Re: Response to Comments, Draft Feasibility Study Report, OU  
Number 6 (Sites 36 and 54), MCB Camp Lejeune, N.C.

**RESPONSE TO COMMENTS  
DRAFT FEASIBILITY STUDY (FS) - SITES 36, 54, AND 86  
OU NO. 6, CTO 303**

**North Carolina Department of Environment, Health and Natural Resources (NC DEHNR)  
Comments Dated August 6, 1996**

DETECTED IRON CONCENTRATIONS IN  
SURFACE AND SUBSURFACE SOILS  
SITE 36, CAMP GIEGER AREA DUMP

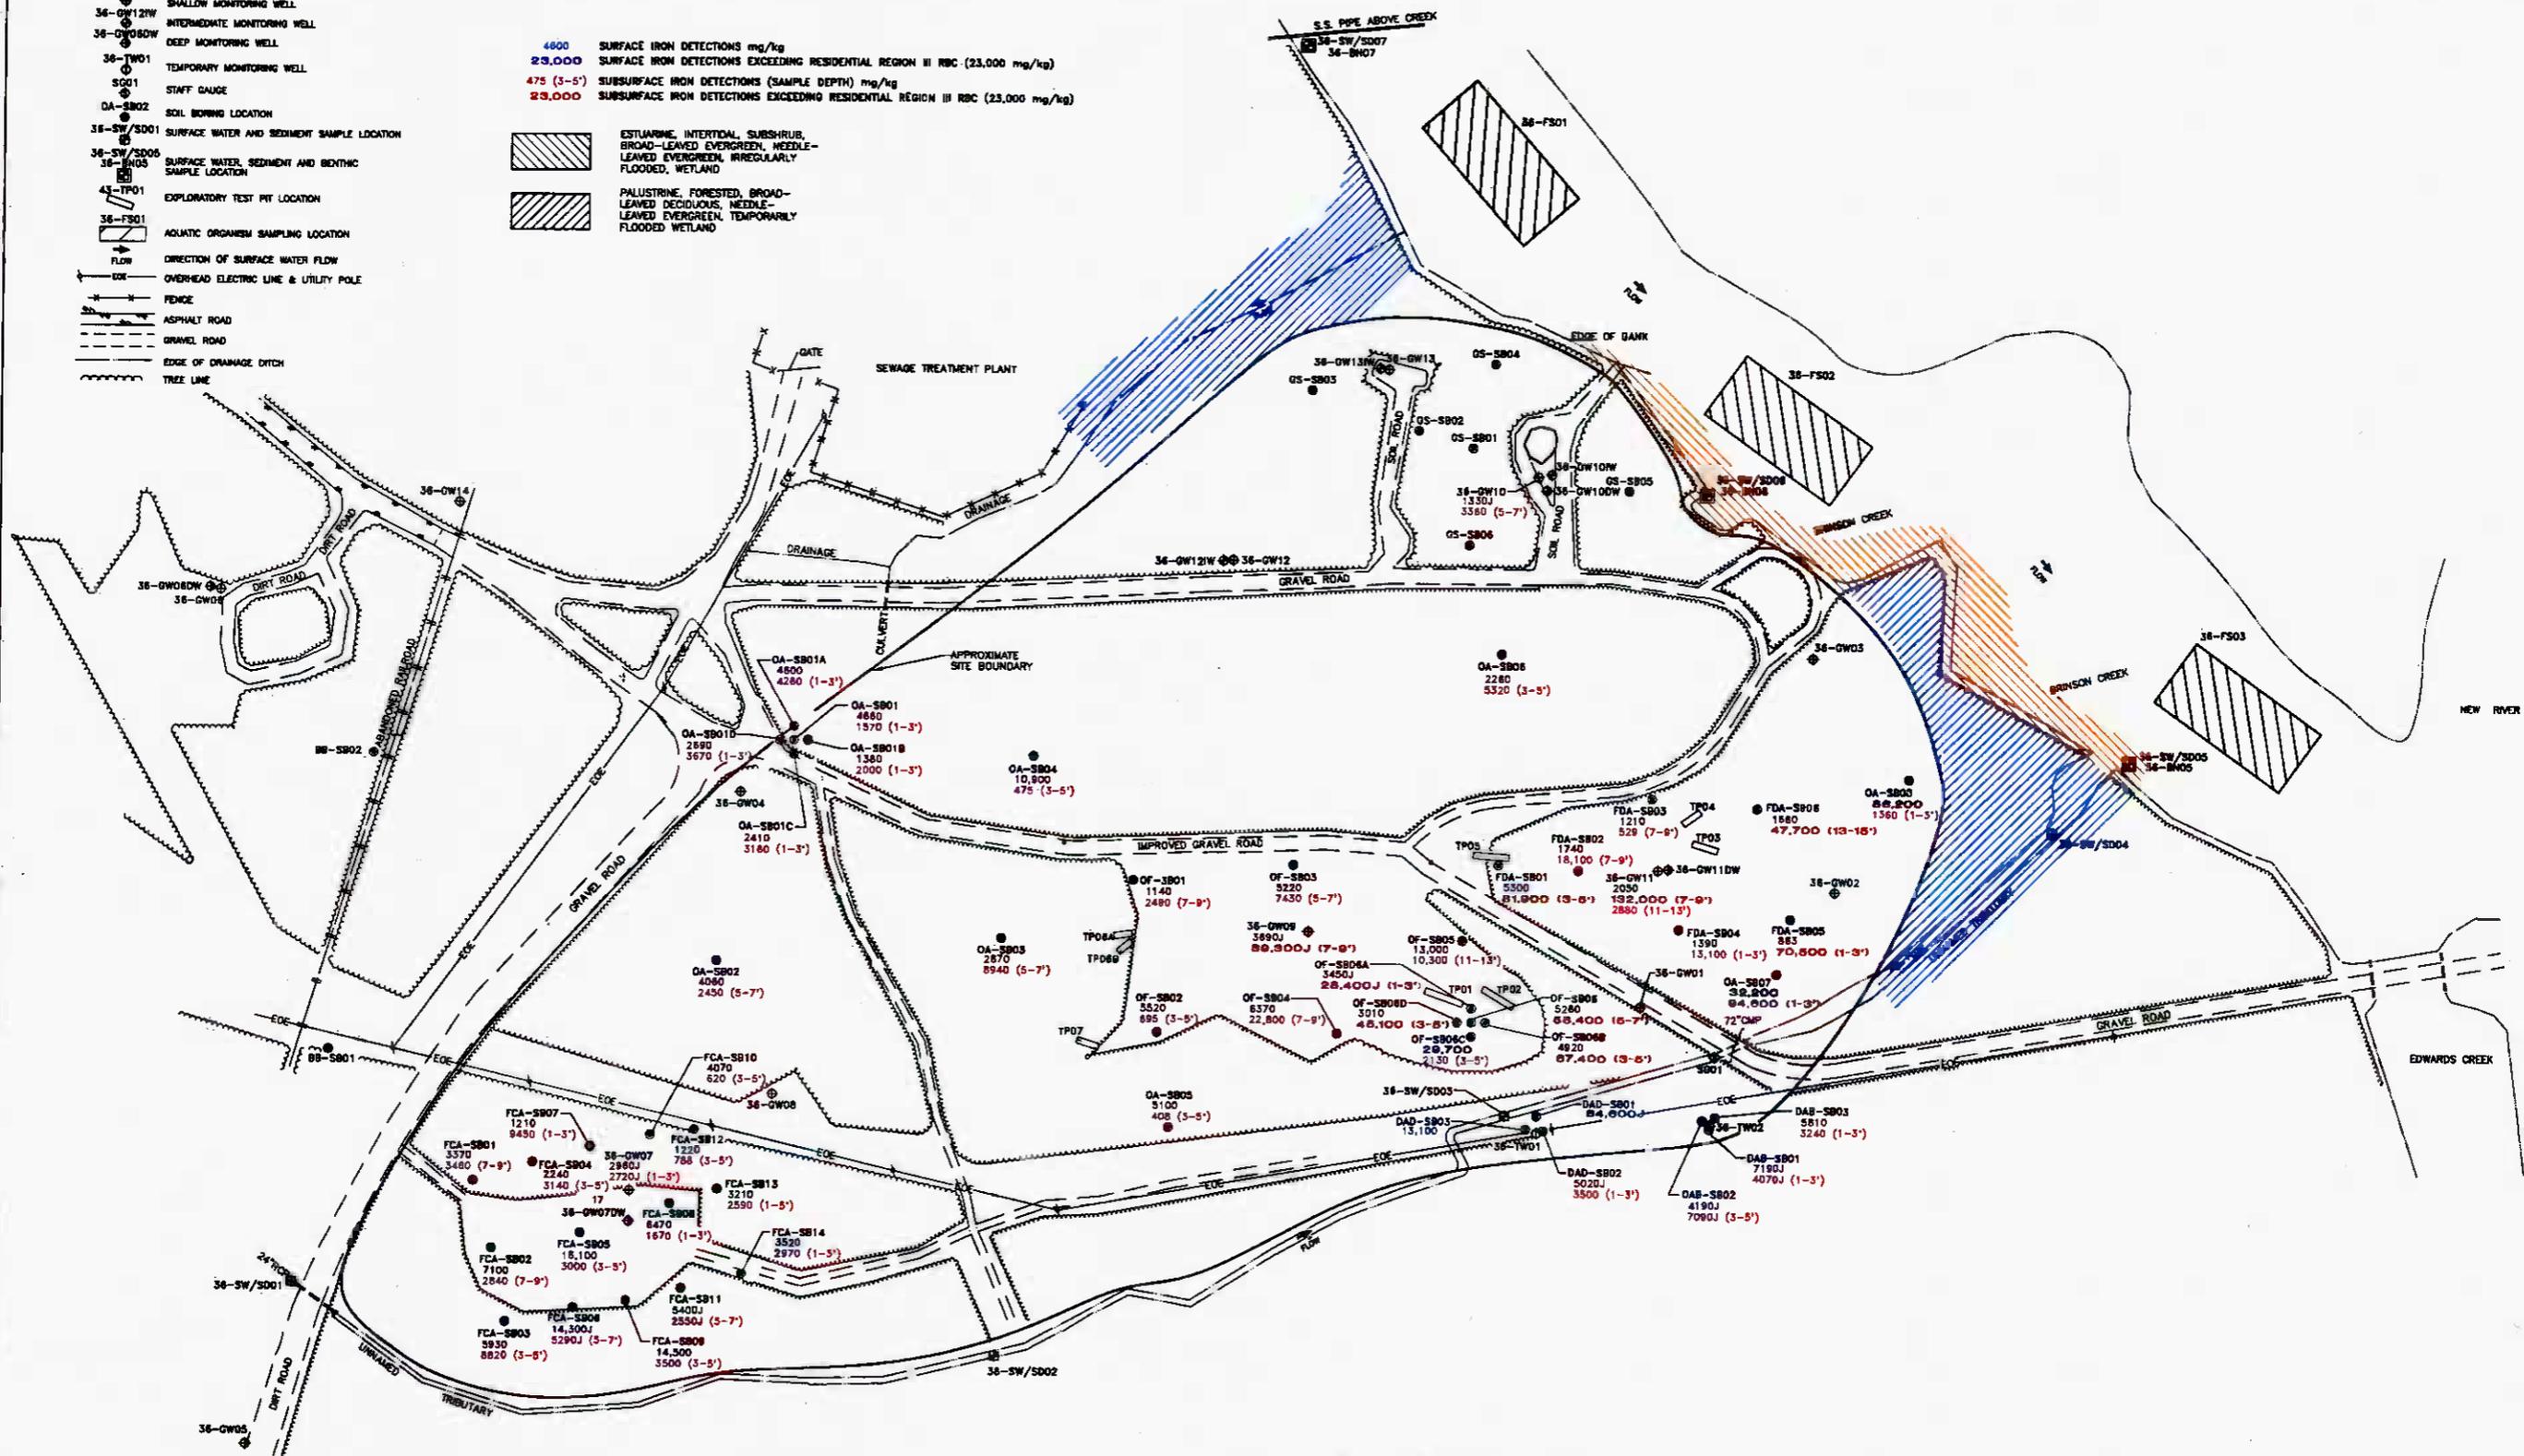
- Iron is an essential nutrient and the toxicity values associated with exposure to this metal are based on provisional studies.
- Although iron was detected above the base background levels in both the surface and subsurface soils, only four of the surface detections exceeded the Region III Risk-Based Concentration (RBC) of 23,000 mg/kg. These four exceedances are scattered over an area of approximately six acres and do not reflect a discernible pattern (see Figure A).

**FIGURE B**  
**U.S. ROUTE 17 BY-PASS IMPACT TO**  
**SITE 36-CAMP GIEGER AREA DUMP**  
 MARINE CORPS BASE, CAMP LEJEUNE  
 NORTH CAROLINA

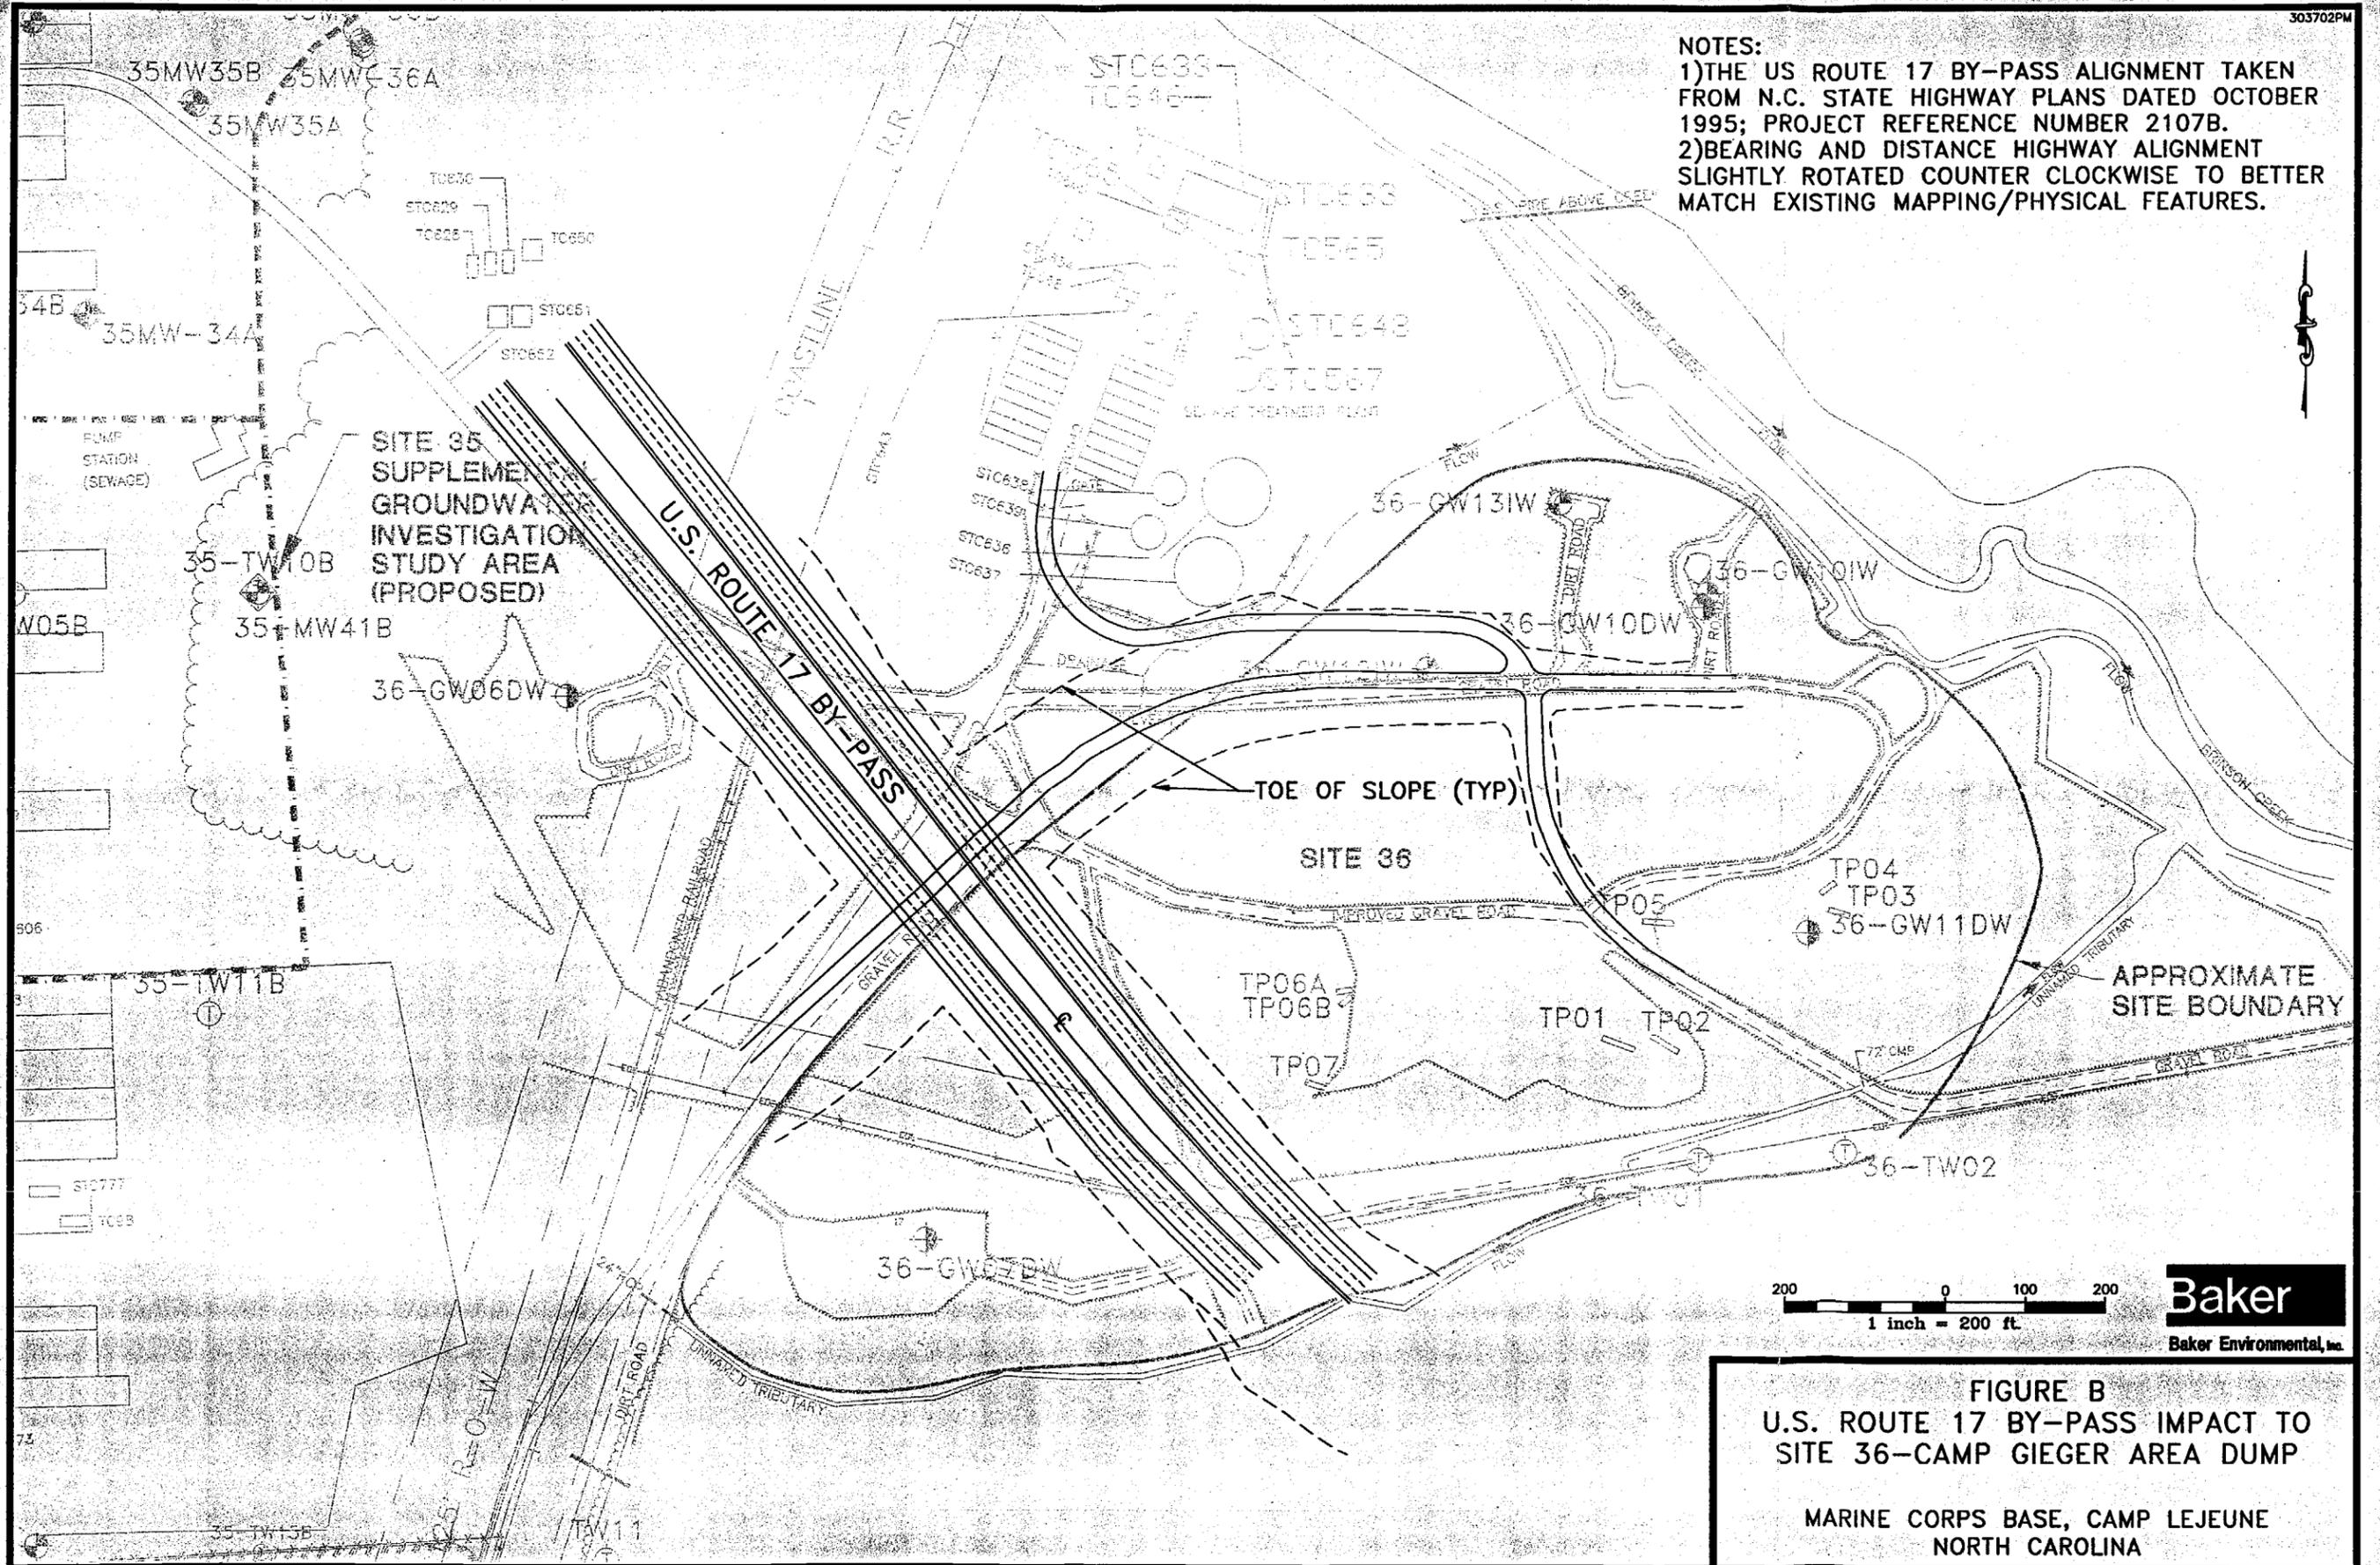
- Although documented within the Final RI and Draft FS, residential development of Site 36 is highly unlikely due to the proximity of the site to the New River and Brinson Creek. The majority of the eastern portion of the site is tidally influenced, and remains inundated and swampy much of the year. Substantial engineering controls would need to be incorporated to either raise the elevation of the site or protect against flooding, each at an anticipated excessive cost, should residential development of the site occur. In addition, the current Base Master Plan does not consider residential or recreational development for this site.
- Figure B identifies the best-known alignment of the U.S. Route 17 Bypass through Site 36. Residential/recreational development in close proximity to this highway is extremely unlikely, as typical setbacks would eliminate much of the developable property.
